# TOWN OF ELIOT, MAINE

## PLANNING BOARD AGENDA

To: Planning Board  
 From: Jeff Brubaker, AICP, Town Planner  
 Cc: Walter E. Pelkey, BH2M, Applicant’s Representative  
 Shelly Bishop, Code Enforcement Officer  
 Date: May 15, 2024 (report date)  
 May 21, 2024 (meeting date)  
 Re: PB23-16: 76 Cedar Rd. (Map 71, Lot 25): Preliminary Plan Application – Residential Subdivision (5 lots)

To: Walter E. Pelkey, BH2M, Applicant's Representative  
From: Jeff Brubaker, AICP, Town Planner  
Cc: Planning Board (for future meeting packet)  
Kim Tackett, Land Use Administrative Assistant  
Shelly Bishop, Code Enforcement Officer  
Interdepartmental reviewers  
Date: April 8, 2024  
Re: PB23-16: 76 Cedar Rd. (Map 71, Lot 25) – Residential Subdivision (5 lots): Town Planner Review Letter 2 – **Preliminary Plan**

SHEET  
**3**

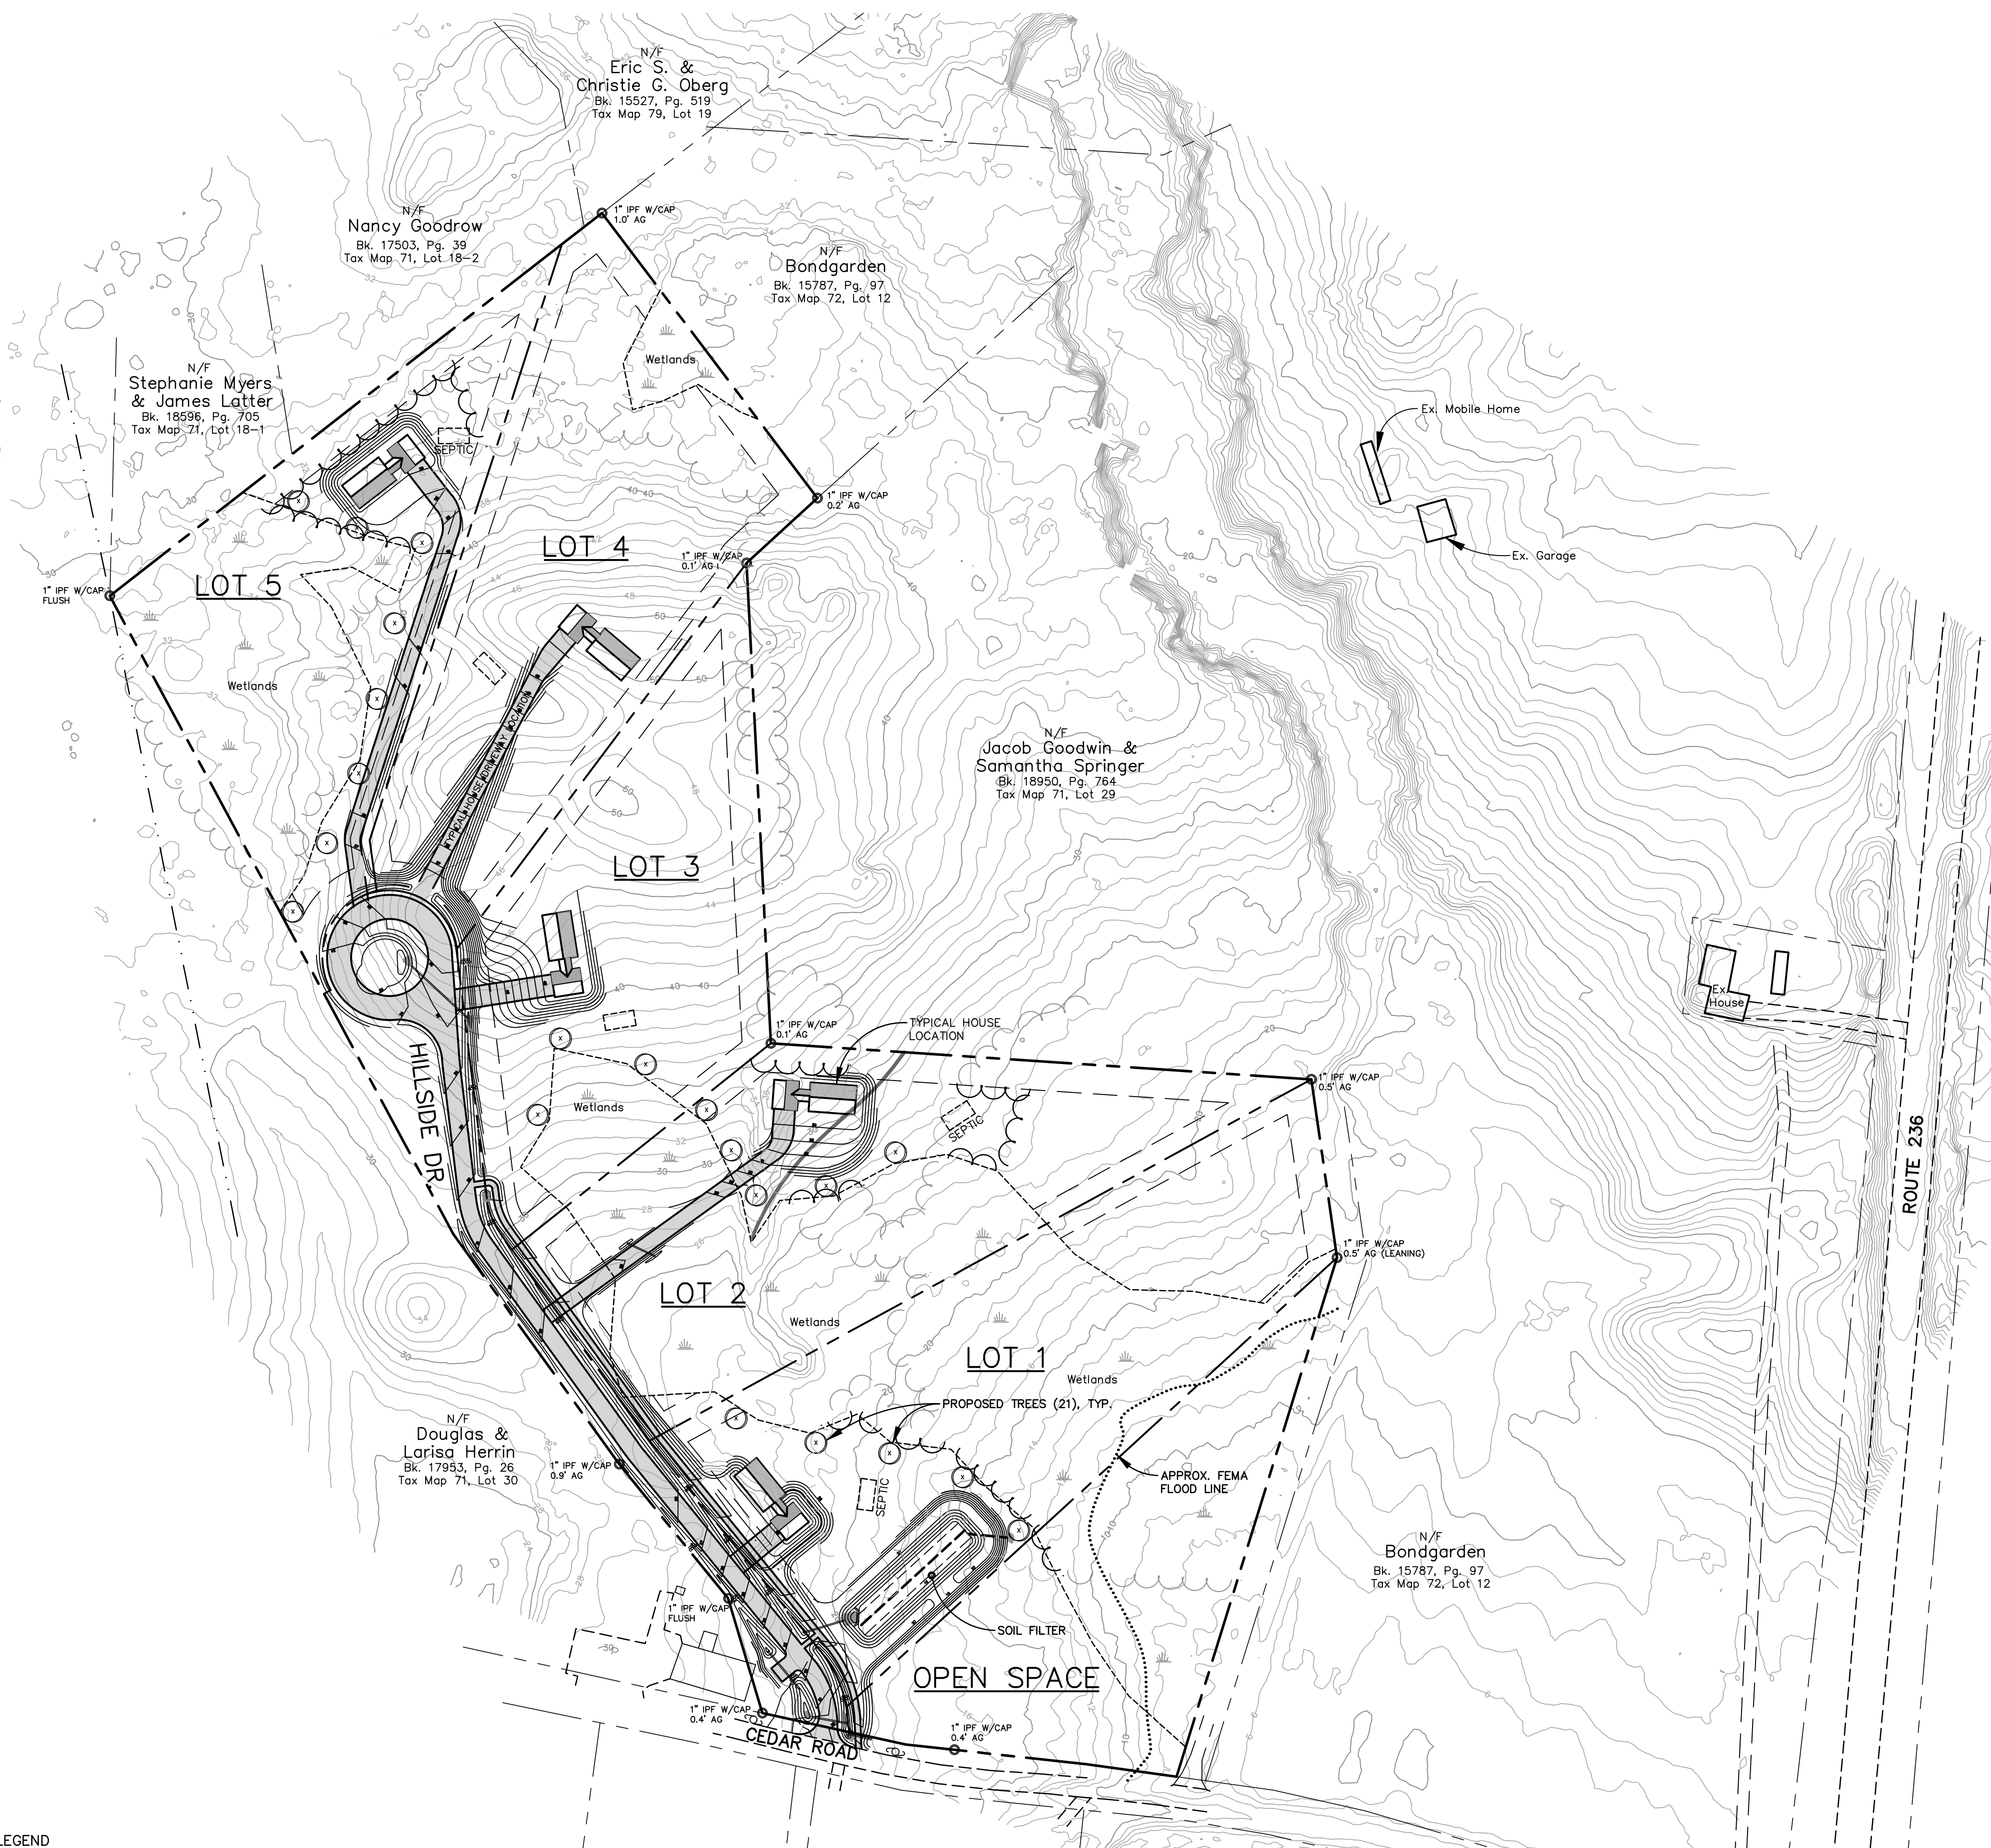
6. I believe a landscape plan will be warranted [41-215] at least to show graded contours based on suggested house locations, preservation of wetlands, and vegetative buffer [41-215(b)] for neighboring properties. However, you may wish to see what the Planning Board requests at their review meeting.

*Site Landscaping (sheet 3) has been added to the plan set to reflect typical home and driveway locations, lot grading, landscaping, and wetland protection measures.*

TYPICAL EROSION CONTROL MEASURES FOR RESIDENTIAL LOTS

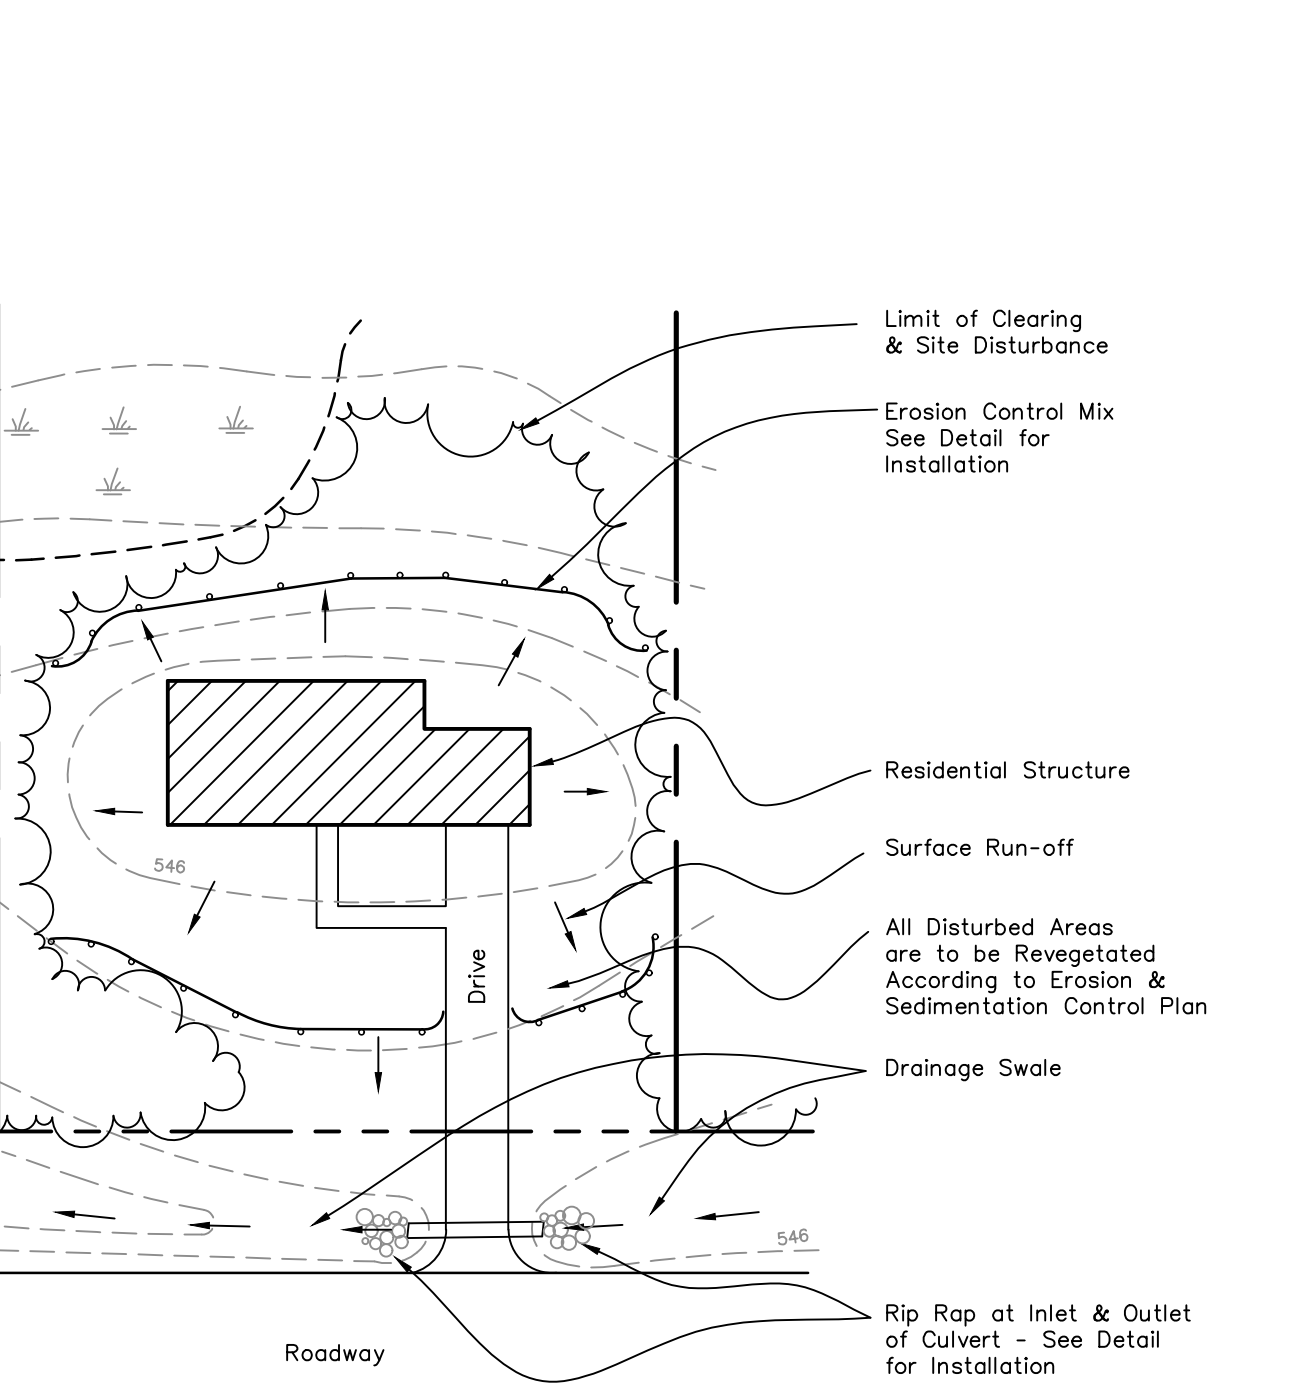
4. Plan should reflect individual lot wetland protection measures discussed during sketch plan review.
5. Path should be 10 ft. wide two-way multi-use path for walking and bicycling as a recreational amenity [41-256, sketch plan review discussion].

*Typical erosion control measures for residential lots detail has been added to sheet 6.*
